# FCC CLASS II PERMISSIVE CHANGE REQUEST LETTER

# RE: FCC Permissive II Change Request for Company: JADAK, a business unit of Novanta Corporation FCC ID: QV5IZAR

We are submitting an application for a class II permissive change to the FCC approval of the Company name: JADAK, a business unit of Novanta Corporation, product description: IZAR RFID Reader (FCC: **QV5IZAR**, Original Grant Date: 05/22/2018). Here are the changes:

# **U1 inside IZAR marked in RED:**

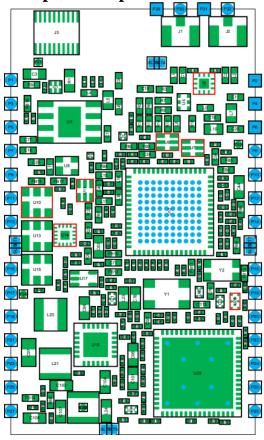
1) The RFID module, with reference designator U1, inside the product sold under the model name IZAR, with the FCC/IC ID as mentioned above, has a few component replacements in the Bill of Materials with similar electrical performance. The RFID transceiver chip inside the RFID module is the same and only the following front-end components in the RFID module, with reference designator U1, of the IZAR reader have changed. (Please note that the reference designators in the following table are component designators of the RFID module and not of the IZAR reader):

U2, U6, U7, U11, U10 are drop-in replacements whereas U14, U26 have associated layout changes. The assembly drawing below shows the position of these components on the board. The layout drawings further down show the differences between the old layout and the new layout.

## **LAYOUT CHANGES:**

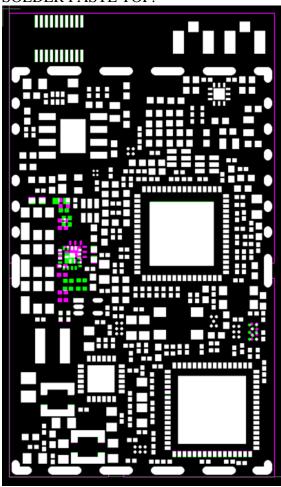
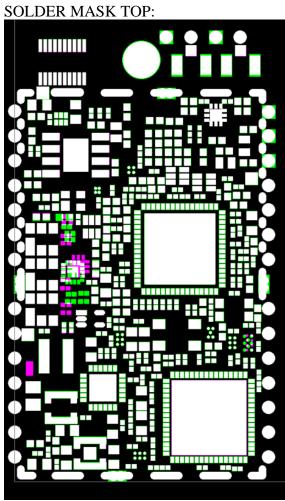
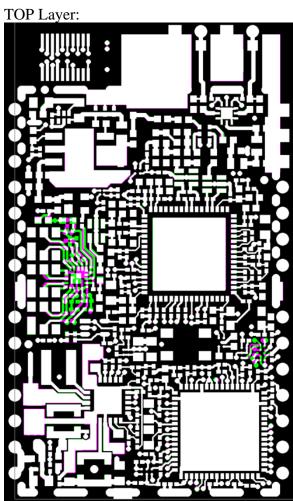
Green: New layout Pink: Old layout

White: Overlap between old layout and new layout
